STAFF REPORT: 10/12/22 REGULAR MEETING

APPLICATION NUMBER: 22-8017

ADDRESS: 3956 W LAFAYETTE

SCOPE: INSTALL SOLAR PANEL ARRAY

Detached garage in rear of property. September 2022 photo by staff.

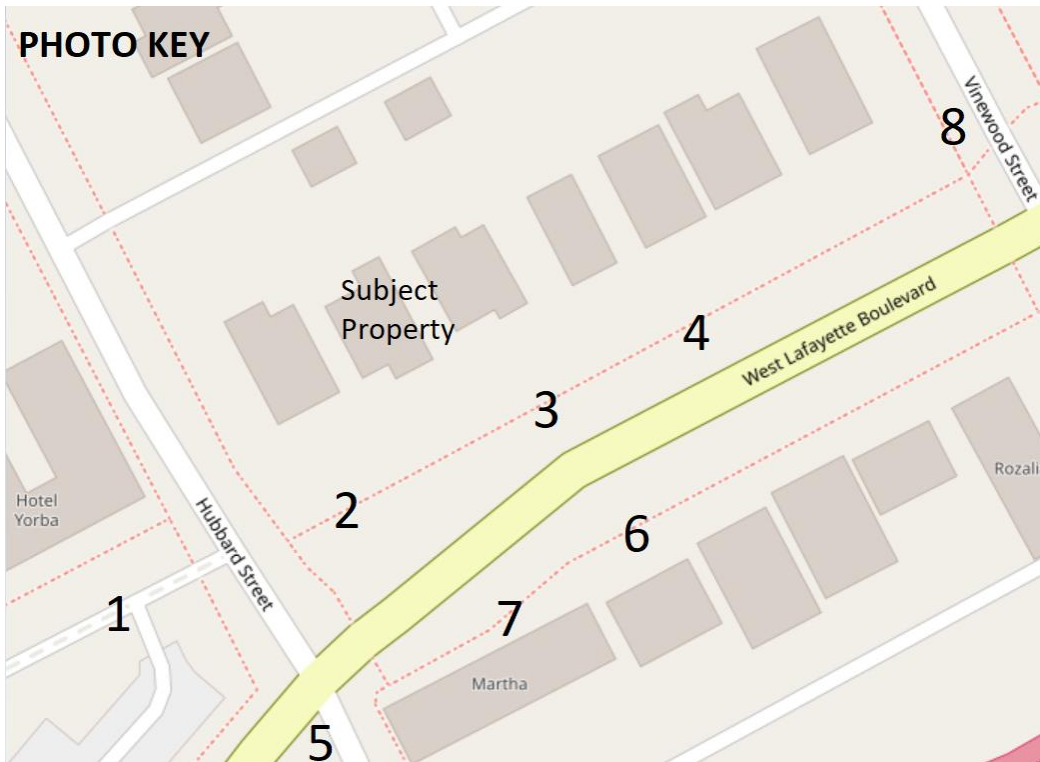
- The application did not state if the garage roof was considered as a location for solar panels.
